8.1.4 Engineering Change: Addition of Anti-Spurious Filter

SMA Inc.**ENGINEERING NOTICE**# 280-9A-001DATE: 99.1.2☒ RUSH

TITLE: OFR-P300F FRONT END
DESIGN MODIFICATION
ECN 280-9A-001

Re: Skytel OFR RX Antenna Conducted Emissions

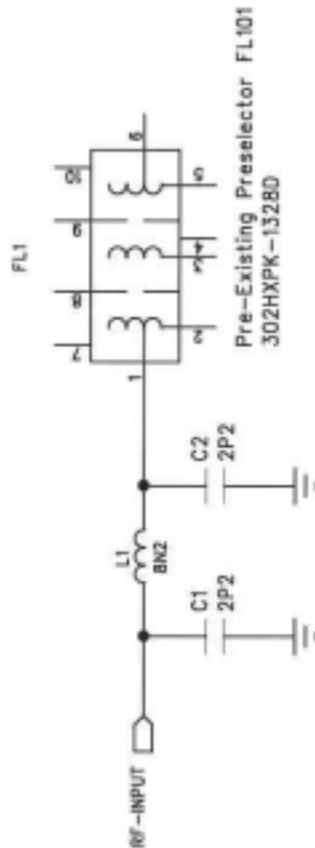
Unit failed FCC Part 15 Antenna Conducted Spurious Emission
Bring design into compliance.**Part Number****Complete Description Of Change**☒ Drawing Chg. ☒ BOM Chg. ☐ Initial Release00M1C030.DWGTo add filter to schematicBOM FE9MAdd 8n2 0603 Inductor, 2pcs 2p7 0603 ceramic capProcess InstructionAdd components on underside of PCB near input to preselectorCut trace and expose groundplane for connectionAdvise to keep center conductor exposure to a minimum**CRITICAL ISSUE**☐ Product Safety☒ Cost Change☐ General Improvement☐ Legal Issues Involved☒ Manufacturing Change☐ Software Change☒ Product Regulatory☐ Marketing Features/Product Specs/Manuals☐ MFG Process or Test Equipment☒ Technical Evaluation Required:

NOTES: COMPONENTS TO BE HAND SOLDERED
ON UNDERSIDE OF PCB
RF INPUT TRACE TO BE CUT AND GROUNDS EXPOSED AS NEEDED
THIS AMENDS 00MIC030.DWG

Engineering Cost Estimate:\$0.20 cost increase + labor**Implementation Notes:**Hand modify existing stock
Update layout when reordered.See report and drawings attached.

Skytel OFR Rx Antenna Conducted Emission
(Unmod'ed)

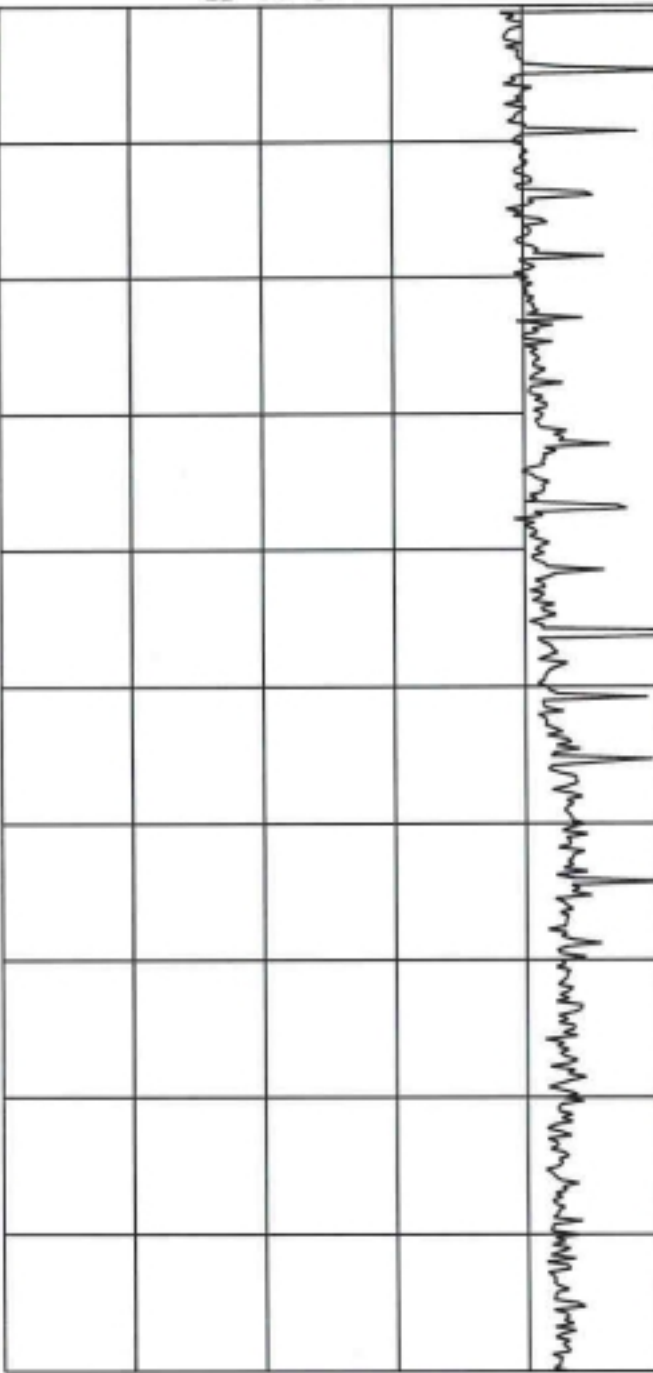
US Tech informed me that the Skytel OFR failed FCC Part 15.111 antenna conducted emissions tests. Any product must radiate less than 2 nW (-57 dBm) at any frequency up to 5 GHz. Some spurs between 2 GHz and 3 GHz violate this requirement or are uncomfortably close.

Skylot OFR Rx Antenna
Conducted Emissions
- Pigtail trimmed back.

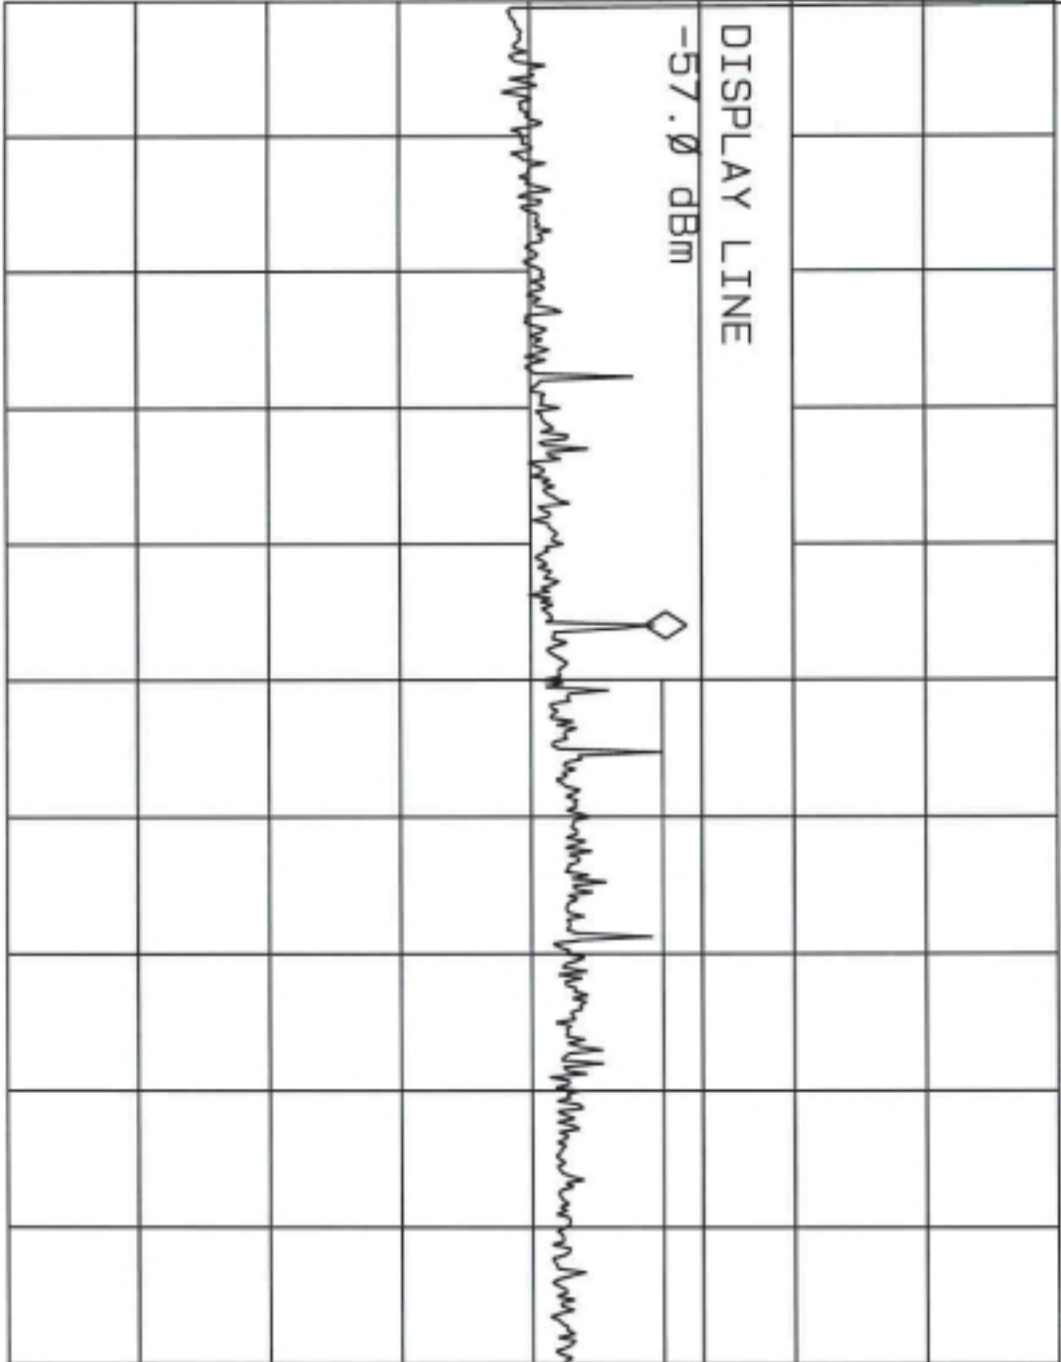
Two changes must be made. The first is a workmanship issue. Any excess exposed center conductor in the input RF connector pigtail acts as a pickup antenna at microwave frequencies. L.O. harmonics are easily picked up. You should use flexible semirigid cable for this application and trim the exposed center conductor at the PCB end of the cable to the absolute minimum length. You cannot allow production to get sloppy with this. The unit I got had over 1/2 inch of exposed wire.

Cable trimming made about 8 dB of difference at 2.3 GHz.

Same as Previous
(Noise Filtered)
>20dB Improvement

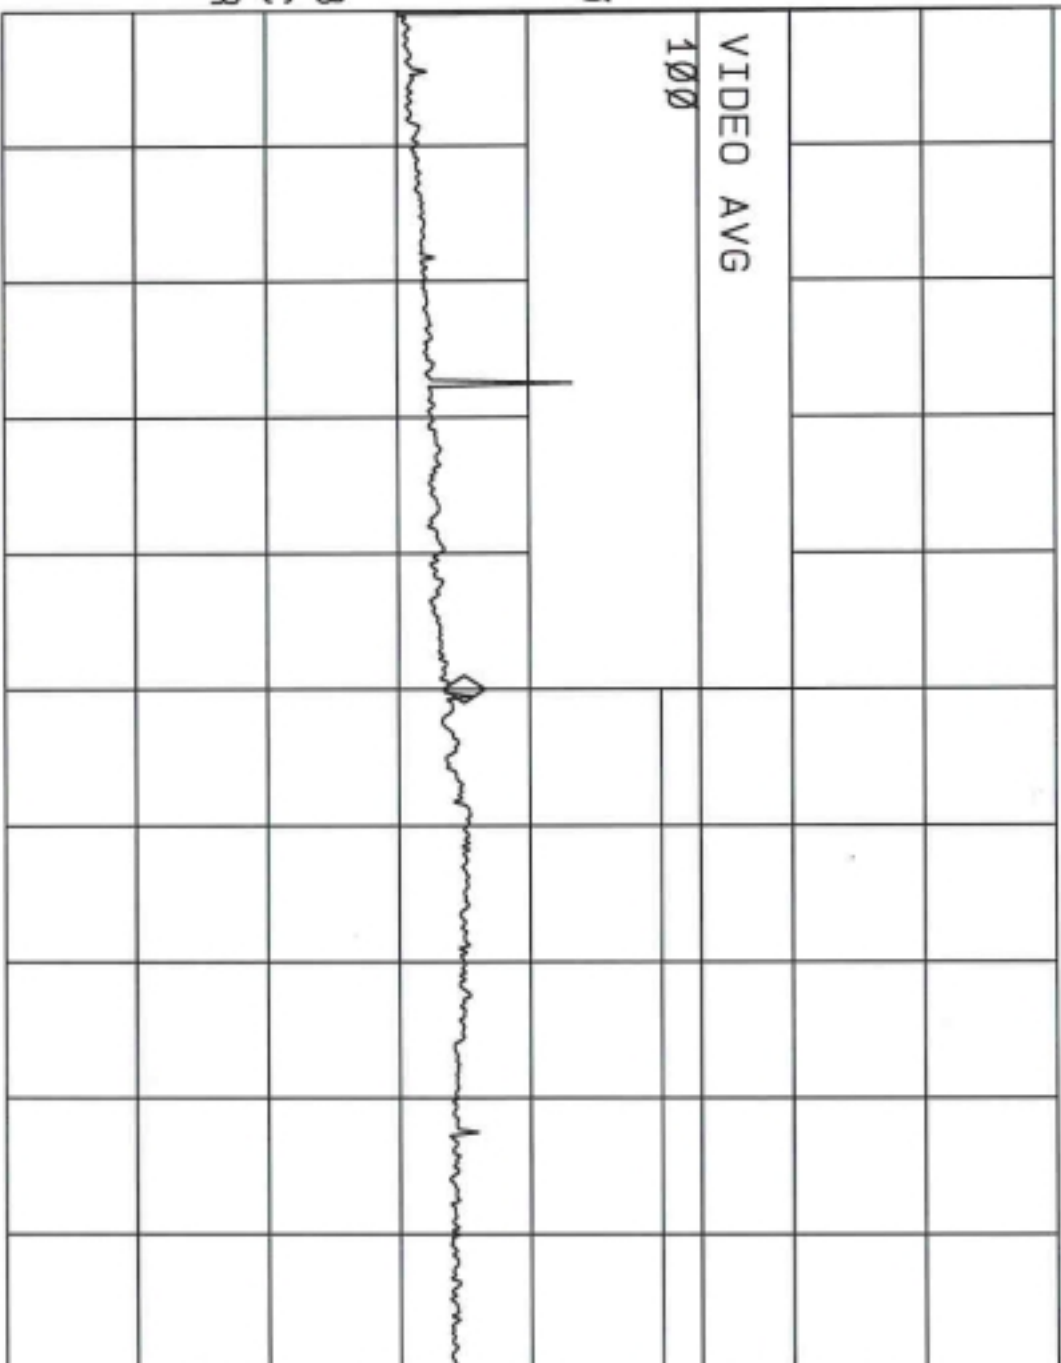
This still left too close a margin. I added a simple PI lowpass filter on the underside of the PCB. This involves a trace cut and removal of some solder mask. 0603 caps and inductors were used. You must implement an Engineering Change Order that adds this filter to all Skytel OFRs. We did not design the L.O. so our bills of materials will not reflect this change, as they call up the module as a single part. SMA can write up the ECO if you wish.

Final performance resulted in spurs so low they were hard to measure. We obtained at least a 20 dB improvement in my estimation. Also, the filter improved the input return loss and front end sensitivity. I postulate that the PI filter acts as a matching network between the connector and helical preselector.
